PROJECT **123A90 - HOLLANDSE KUST NOORD WIND PARK**
BLPH Project

MECHANICAL COMPLETION DOSSIER (ONSHORE)

Junction Box 00-JE-21001 and Multi-core cable (SIS System)

C30002377

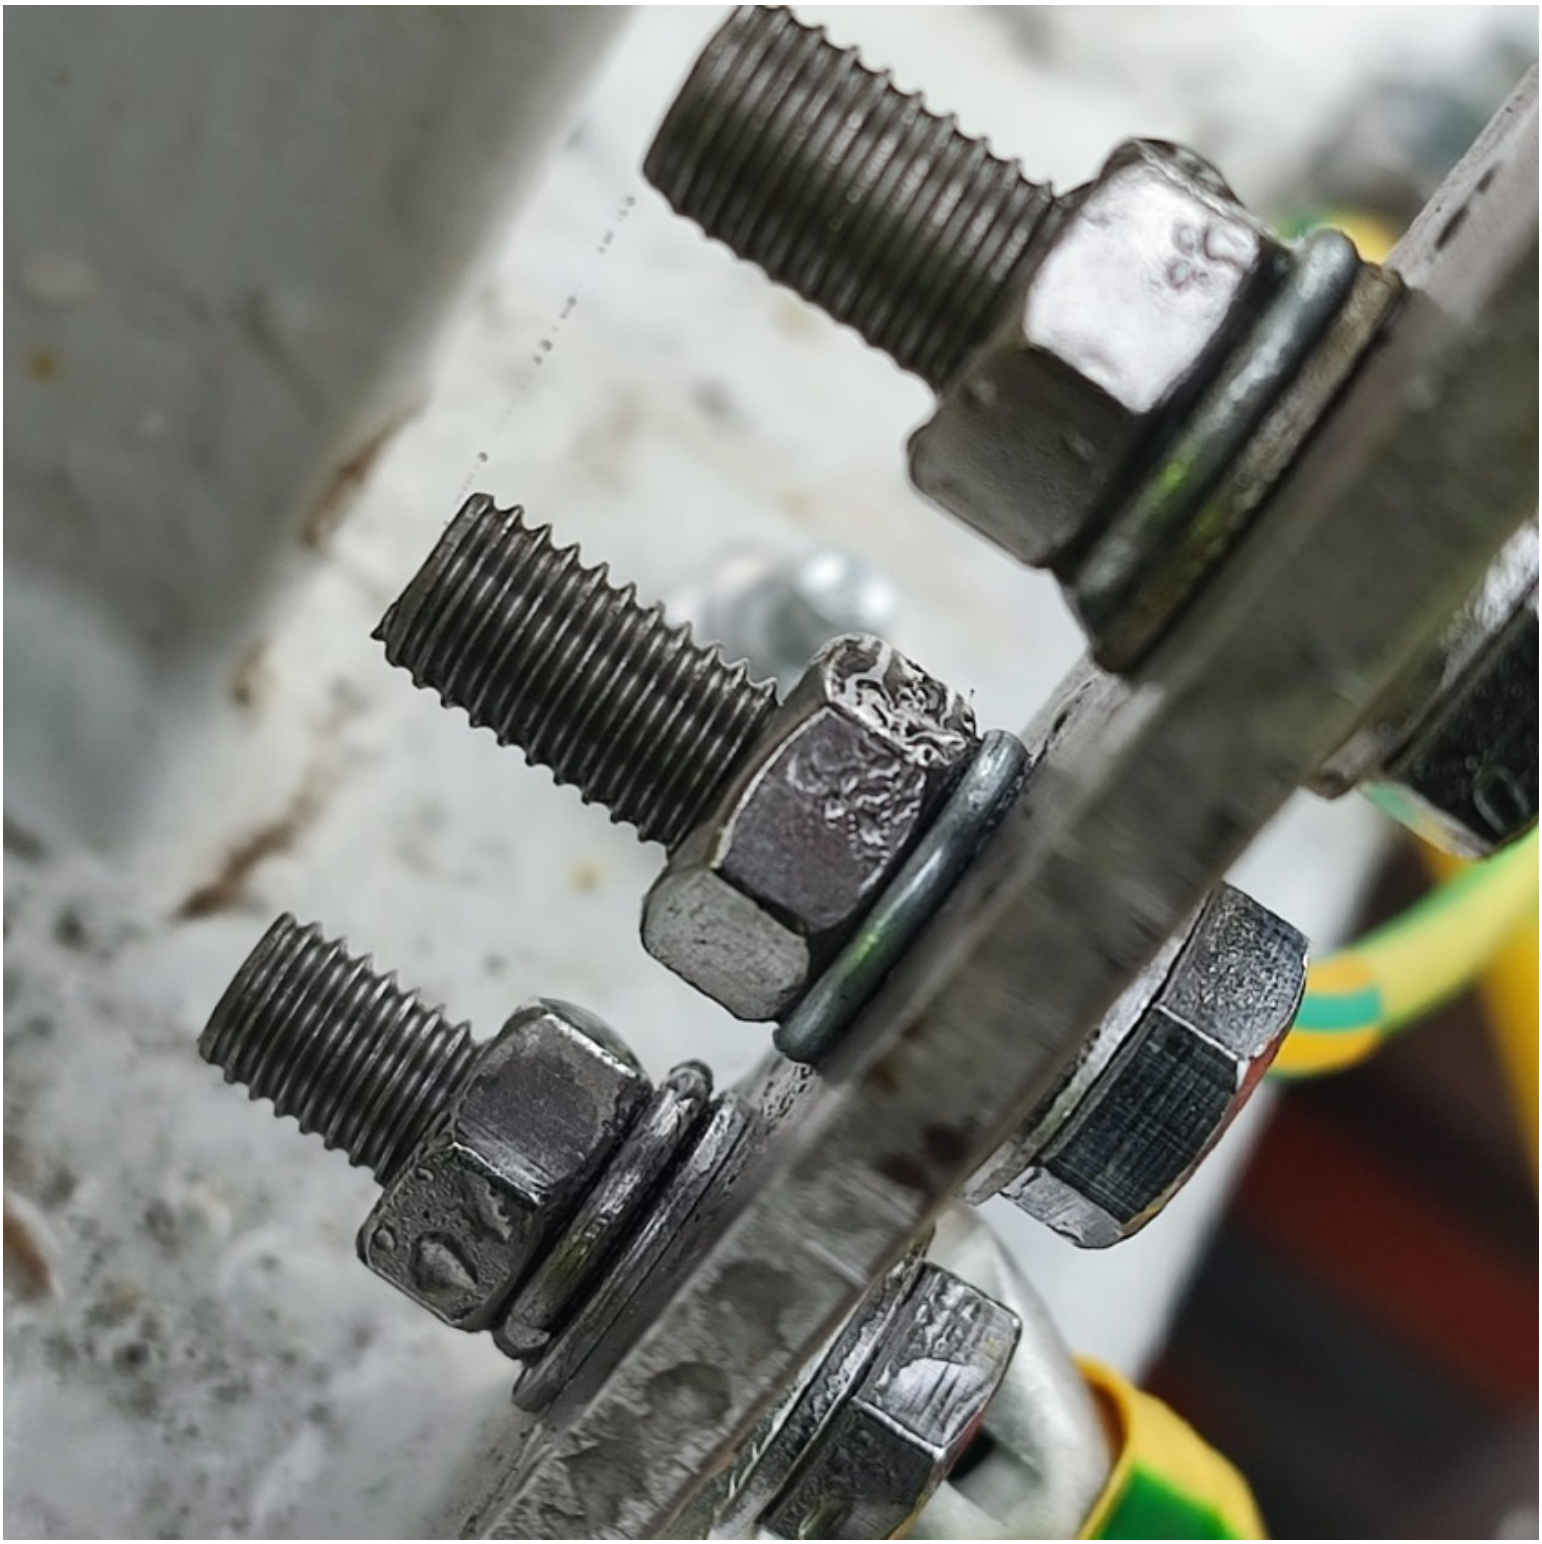
Missing on the earthing connection on the BTM the growers.And the others is different materials. (not in SS).

DONE

C30002379

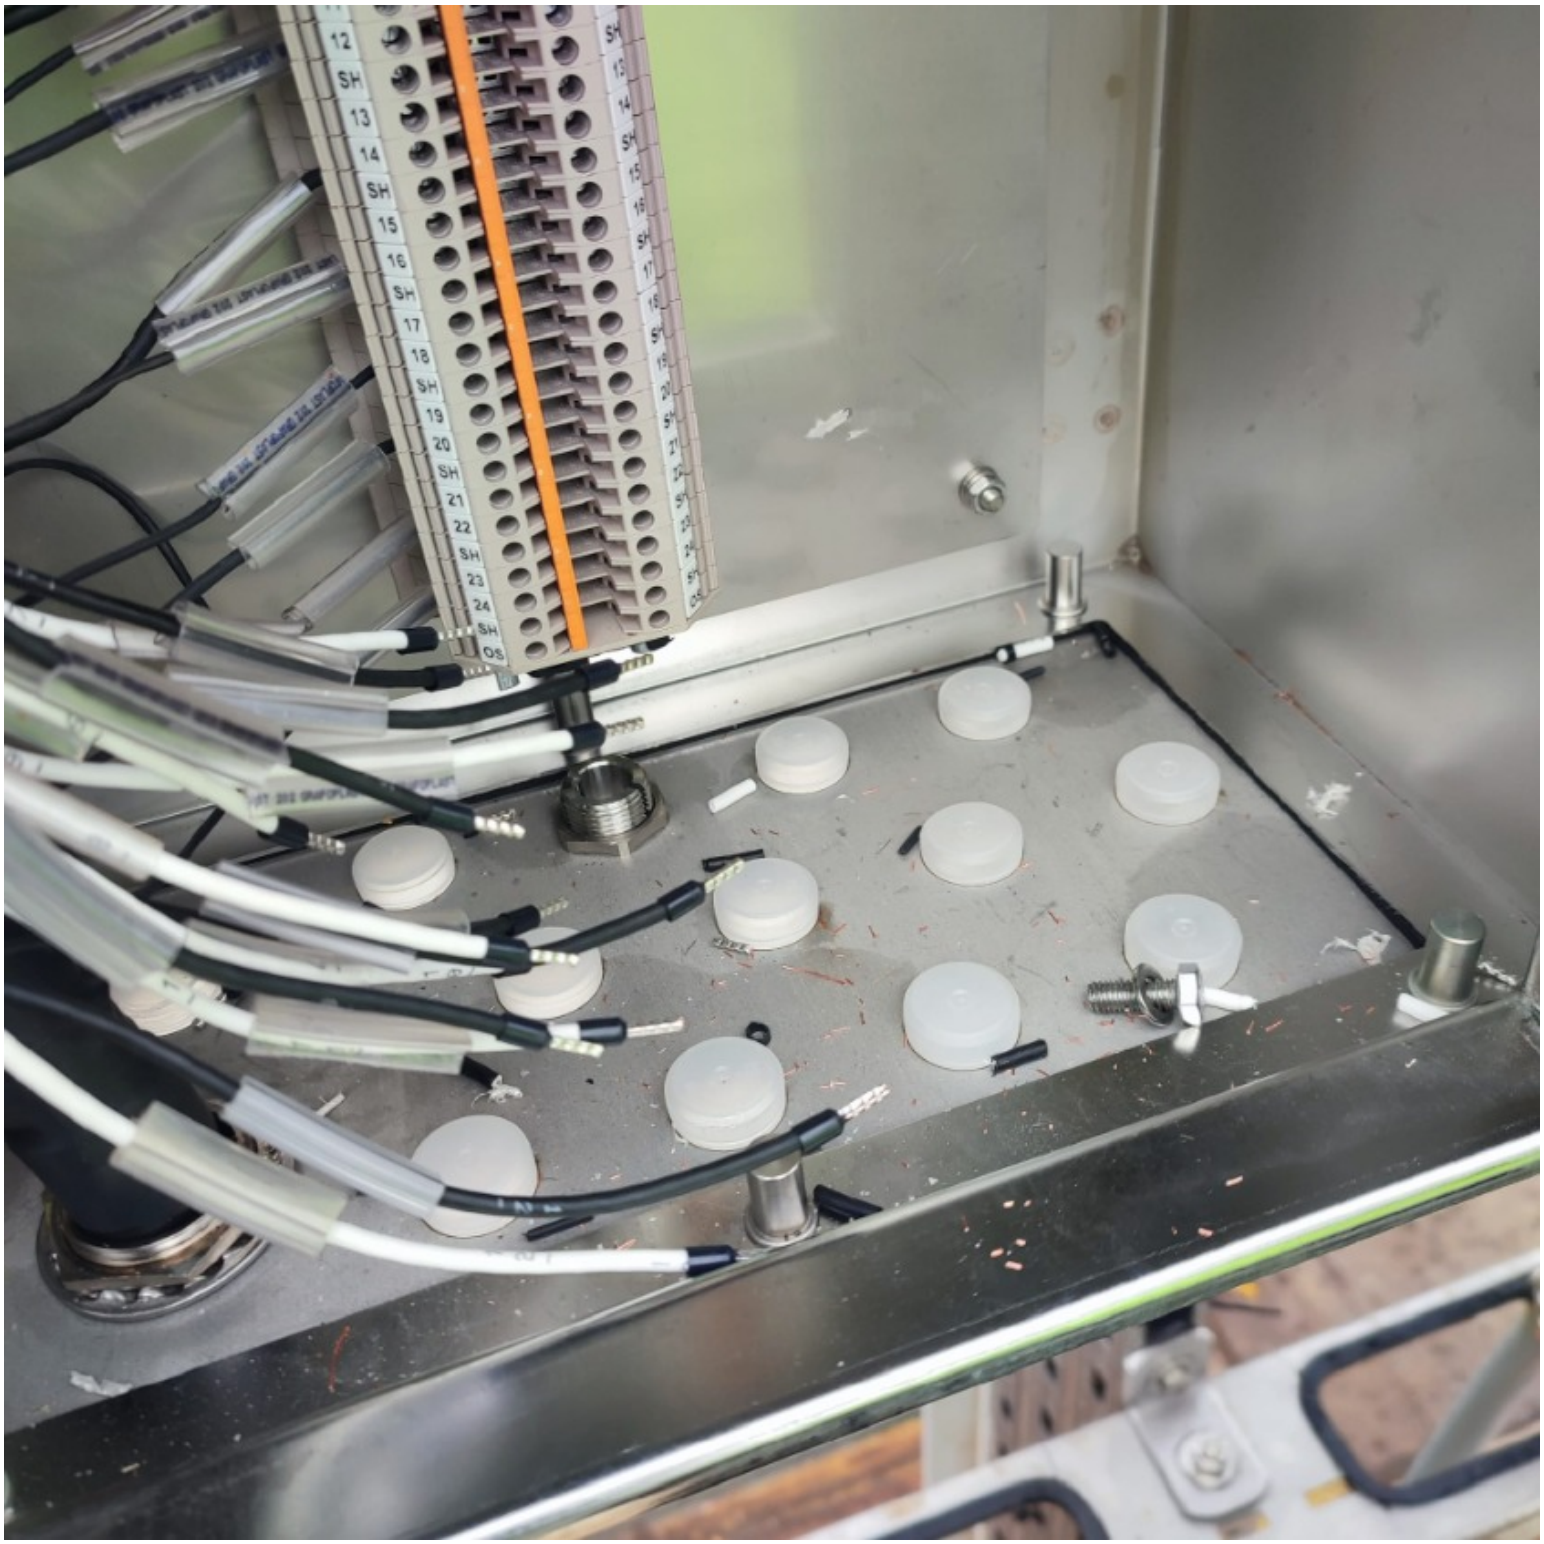
Missing all plugs internal 00-JE-21001. See attached photo.

DONE
